Upper South Creek Advanced Water Recycling Centre – Response to Request for Information 42286993 – waterway health

11 July 2022

Attachment A Response to EPA comments on design matters

Figure 3-1 Size of 150 ML wet weather storage at AWRC site

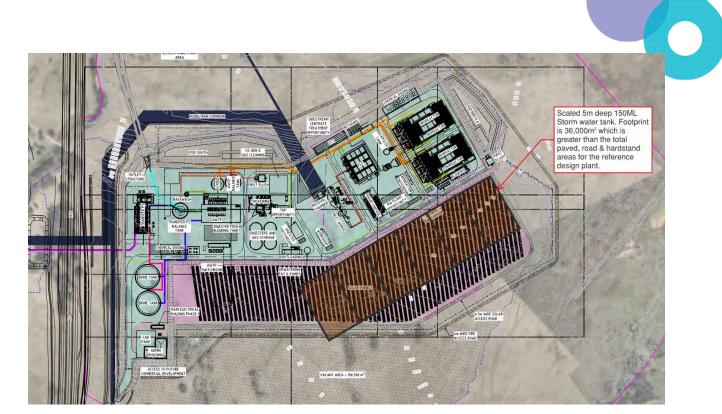
The EPA considers there are sufficient grounds for the development of this additional storage capacity. The ability to store and prevent the discharge of 165 ML/day of effluent on just one 'peak day' would appear to remove about 80% of the total yearly discharge of only primary

Clarification should also be provided around the accuracy of the RtS statement above. The EIS indicates that up to 144 ML of flows can be discharged per day before primary treatment is required during severe wet weather. Sydney Water should provide confirmation that the 165 ML/day figure refers to additional flows that could potentially enter the plant during the day above the existing 144 ML/day maximum non-primary treatment capacity, rather than the overall plant peak daily flow. If the RtS statement above is referring to the overall plant peak daily flow, the infrastructure required to store a peak day's flows would be substantially less than the 165 ML/day stated.

For the discussion, we have assumed a nominal volume of 150 ML/day is required to prevent any primary treated effluent discharge to South Creek. This equals 3 x ADWF which is nominally the maximum wet weather flows above tertiary treatment. The storage would likely need to be slightly larger to provide complete containment for a peak day event.

Storage of 150 ML with a tank about five metres deep (which is the depth of the primary and chlorine contact tank), would require a footprint of about 350 m x 100 m. This is equivalent to the footprint of about 30 Olympic swimming pools. Installing this amount of storage would take up a significant area on the site, complicating and limiting space for other uses such as solar panels and future stages of the AWRC. Figure 3-1 shows the impact that storage of this size would have on the plant footprint. It would also not be practical to cover a tank of this size.

The footprint of the storage is greater than the total hardstand and roads for the remainder of the AWRC site.

Figure 4-3 View downstream of Wallacia Weir highlighting the grade of the riverbank on the left

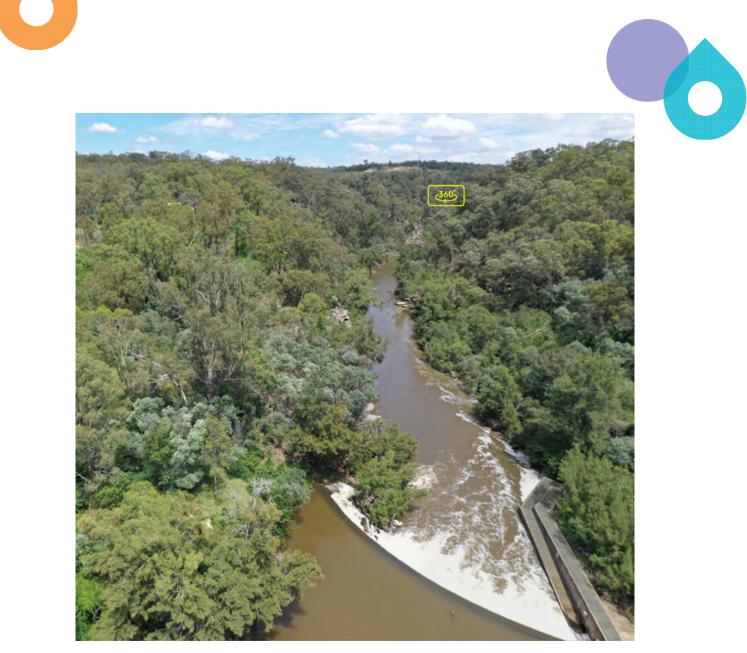
- Outline further the construction issues associated with a downstream location
- Further clarify any recreational areas downstream that may be impacted (if any) and assess the impacts to these areas relative to the current discharge location
- Model the toxicity impacts of this downstream discharge location compared to current discharge point (including justification that limited levels of dilution would occur relative to the current discharge.

Sydney Water has further considered locating the treated water release downstream of Wallacia Weir in response to concerns raised by EPA. The following risks/constraints have been identified for constructing, operating and maintaining a release structure downstream of Wallacia Weir.

- As shown in Figure 4-2 and Figure 4-3, the riverbanks of Nepean River are considerably higher and steeper downstream of Wallacia Weir. This rocky steep terrain would pose significant challenges and risks in relation to construction safety. This would require a longer construction period and a considerable increase in capital cost.

Figure B2 Predicted dilution profile for the Nepean River for releases between 1.3 and 1.7 x ADWF (2036 releases)

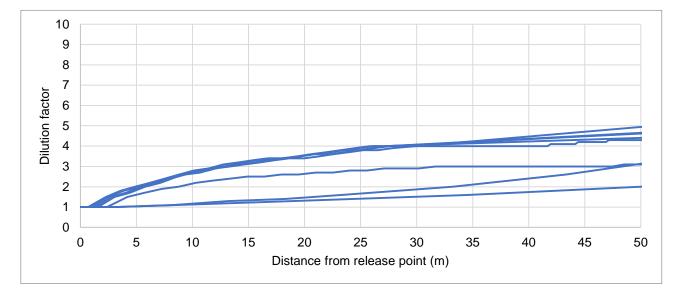
of the near field mixing zone (which is at least 50m) during extreme wet weather events. Based on this very basic assessment and the mixing zone results for the identified toxicants in the EIS, the discharge represents a risk to the protection of the environmental values in the Nepean River under extreme wet weather. described in section 6.2.1.2 and Figure 6-152 of the Hydrodynamic and Water Quality Impact Assessment (Appendix F of the EIS).

These dilution profiles are presented in Figures B2 and B3 (included after this table). For completeness, the results from the third release category (>3 x ADWF) are also included as Figure B4.
